RADIO SERVICING

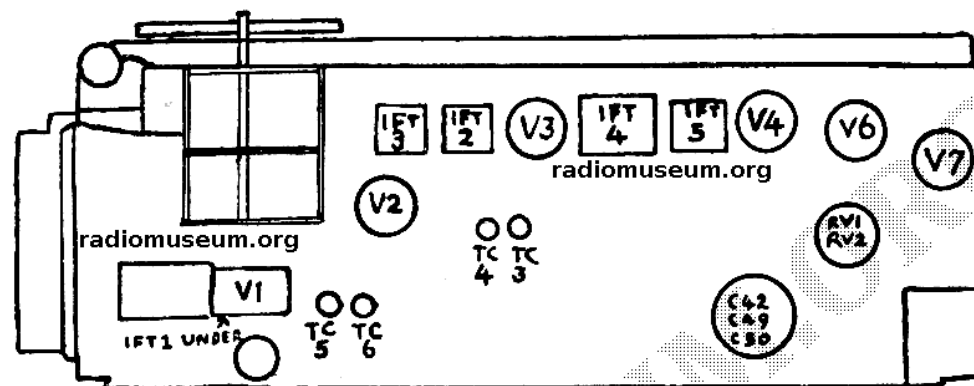
bias resistor for V1a and the grid of V1a connected directly to chassis. Tuner H.T. line was 120 volts. In later models R19 is 39k. R33 (68k) is now fitted between junction of RV1/R18 and pin 9 of V6 (H.T. line). VHF72, R18 is now 820 ohms, R19 now 39k, R37 (150k) now between junction RV1/R18 and pin 9 of V6.
